SERVICE BULLETIN

SB-10-004

IMPORTANT NON-COMPLIANCE EQUIPMENT RECALL NOTICE – Dealer Notification

AERO – RAD RECALL NOTICE

Detail 3

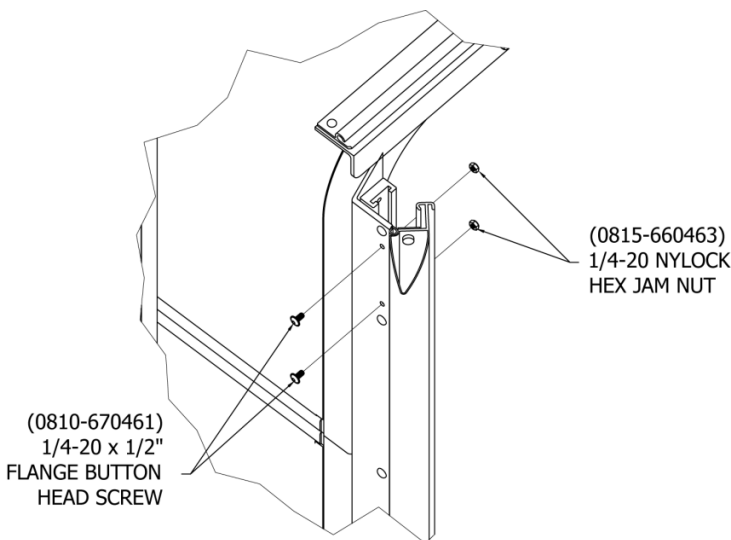
Locate the top two rivets on the angle side of the hinge. Using the included "G" drill bit, drill holes 1.25" below the top rivet and 1.25" above the bottom rivet. Holes are to go through the hinge and the angle. (Do not drill through the side wing.) All rear lock details show the driver side. The passenger side is to be done the same.

Detail 3A

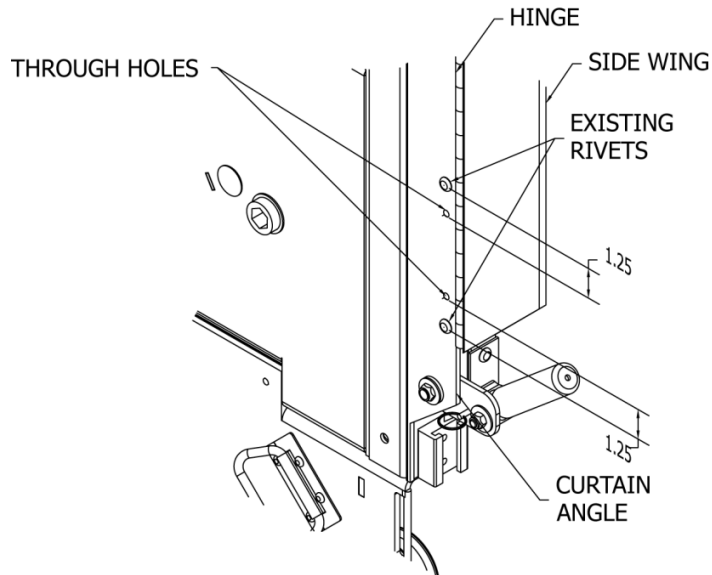
Locate (2ea) 1/4"-20 x 1/2" Flange Button Head Screws and (2ea) 1/4"-20 Nylock Hex Jam Nuts in the hardware pack. Insert the screws as shown. Open side wing to gain access to screw threads. Attach Jam Nuts. Tighten using the (1)

included 5/32" Allen Wrench and (1) 7/16" Wrench.

Detail 4

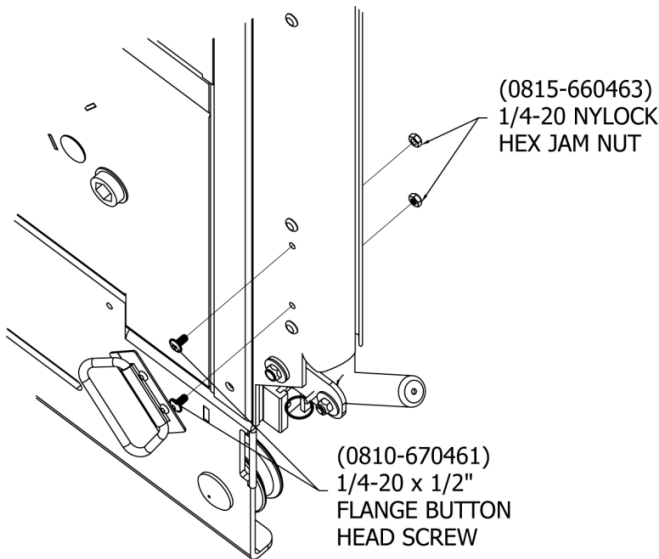
Locate the bottom two rivets on the angle side of the hinge. Using the included "G" drill bit, drill holes 1.25" below the top rivet and 1.25" above the bottom rivet. Holes are to go through the hinge and the angle. (Do not drill through the side wing.)

Detail 4a

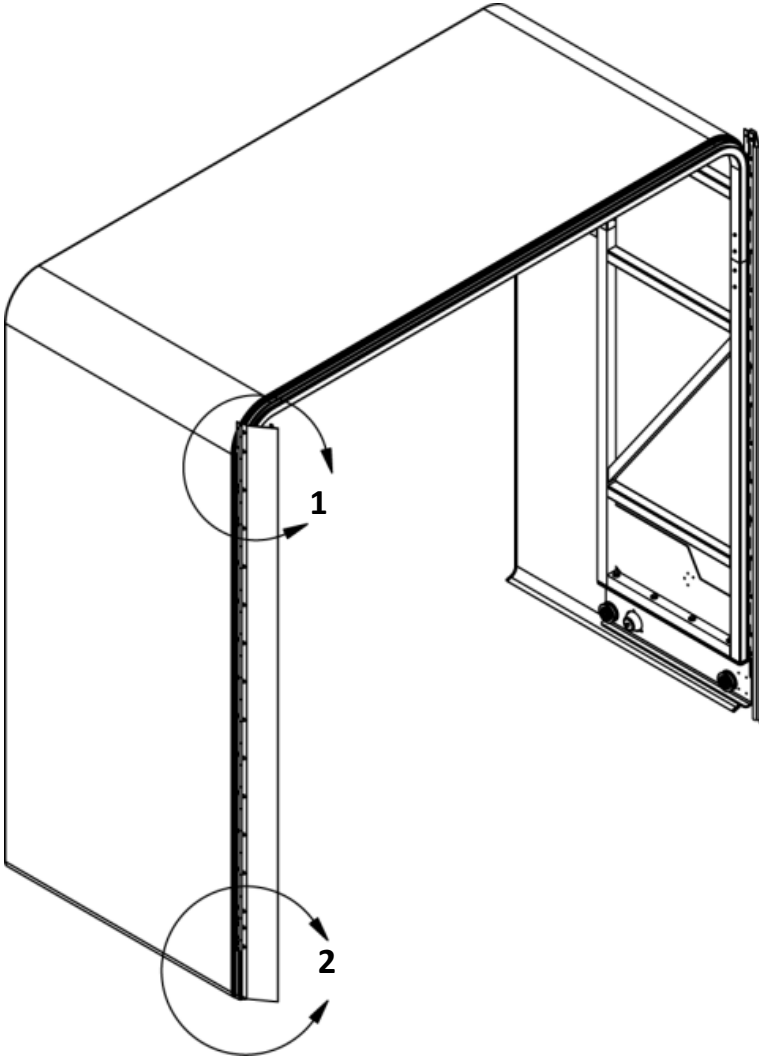
Locate (2ea) 1/4"-20 x 1/2" Flange Button Head Screws and (2ea) 1/4"-20 Nylock Hex Jam Nuts in the hardware pack. Insert the screws as shown. Open side wing to gain access to screw threads. Attach Jam Nuts. Tighten using the (1) included 5/32" Allen Wrench and (1) 7/16" Wrench.

Detail 1

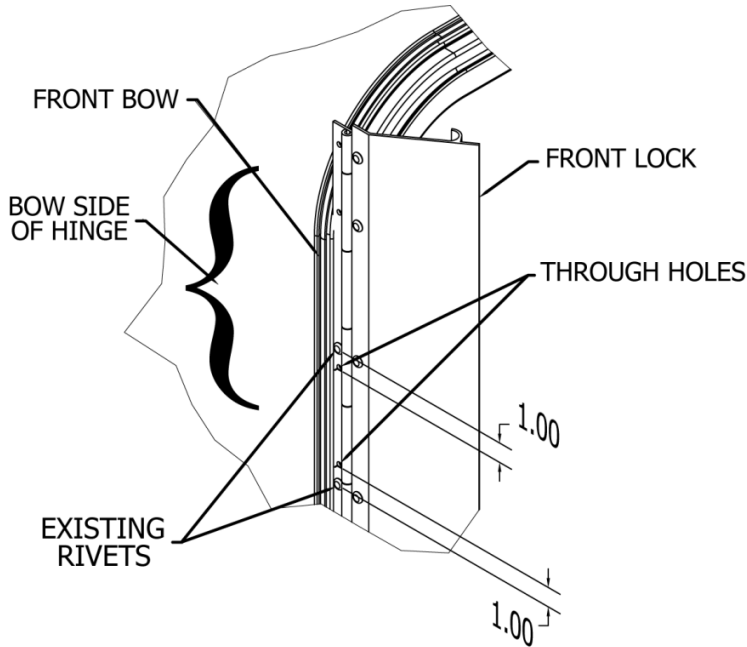
Locate the top two rivets on the bow side of the hinge. Using the included "G" drill bit, drill holes 1" below the top rivet and 1" above the bottom rivet. Holes are to go all the way through the hinge and both walls of the bow. All front lock details show the passenger side. The driver side is to be done the same.

Detail 1A

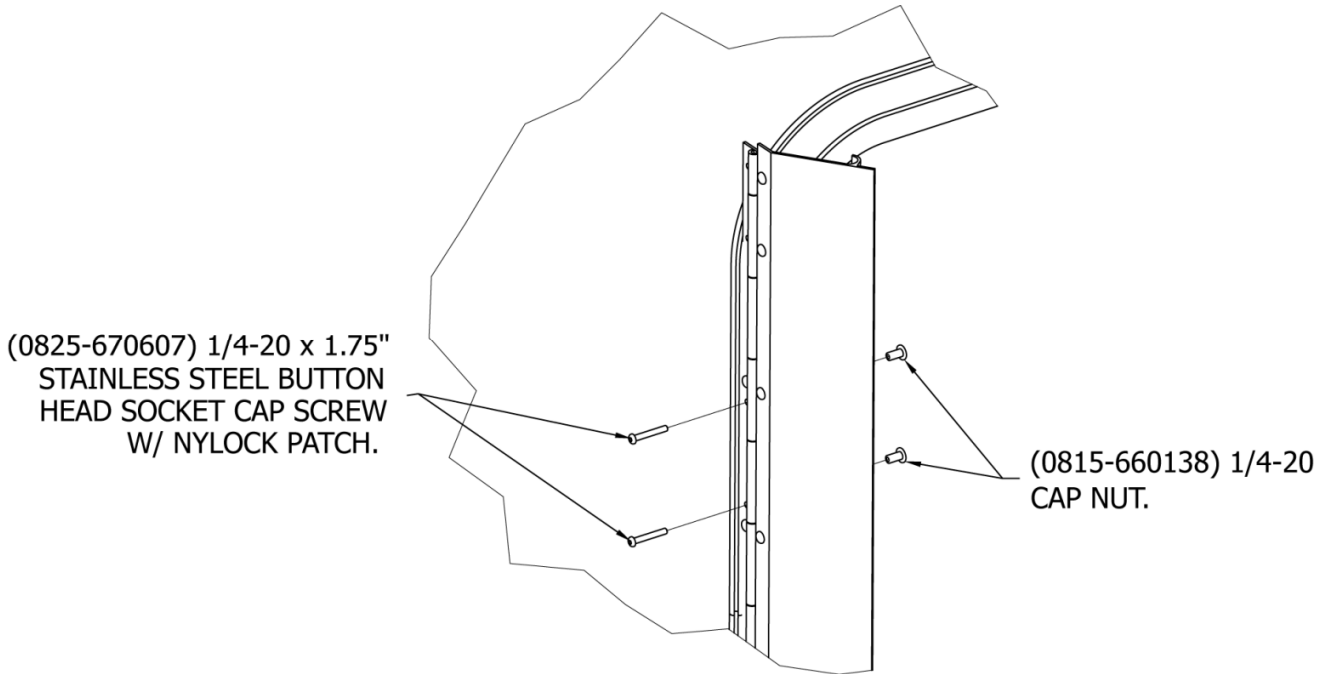
Using the included 3/8" drill bit, enlarge the two holes from the previous step. Drill through the inside wall only.

Detail 1B

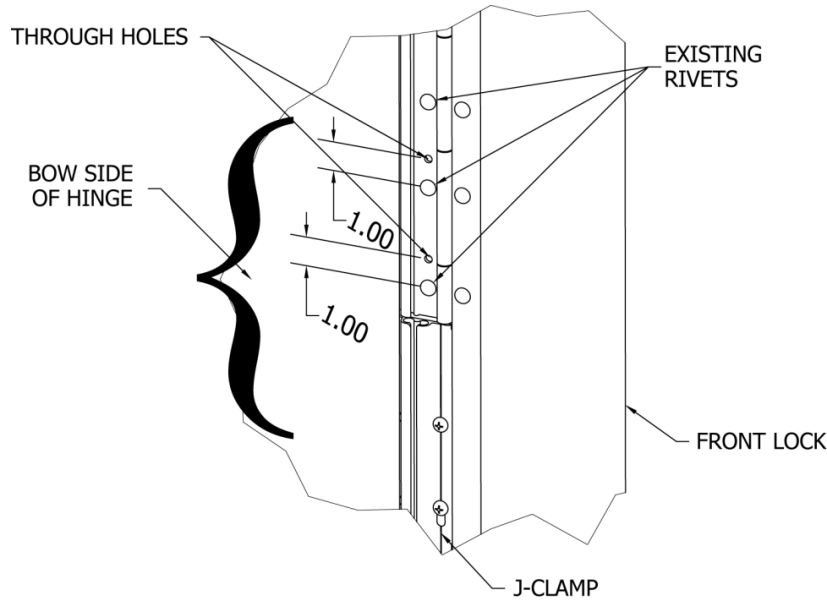
Locate (2ea) 1/4"-20 x 1.75" Stainless Steel Button Head Socket Cap Screws and (2ea) 1/4"-20 Cap nuts in the hardware pack. Insert the cap nuts in the 3/8" holes on the inside wall of the front bow. Insert the button head screws through the bow and into the cap nuts. Tighten using the (2) included 5/32" Allen Wrenches.

Detail 2

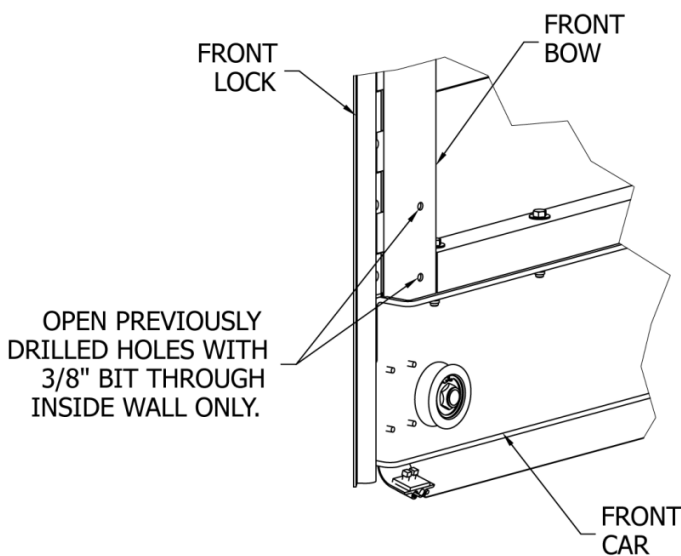
Locate the bottom two rivets on the bow side of the hinge, just above the J-Clamp.

Using the included "G" drill bit, drill holes 1" above each of the two rivets. Holes are to go all the way through the

hinge and both walls of the bow.

Detail 2B

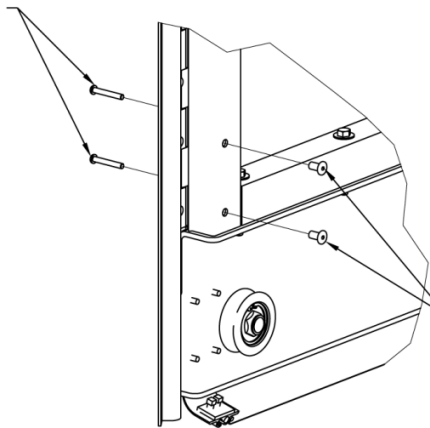
Locate (2ea) 1/4"-20 x 1.75" Stainless Steel Button Head Socket Cap Screws and (2ea) 1/4"-20 Cap nuts in the hardware pack. Insert the cap nuts in the 3/8" holes on the inside wall of the front bow. Insert the button head screws through the bow and into the cap nuts. Tighten using the (2) included 5/32" Allen Wrenches.
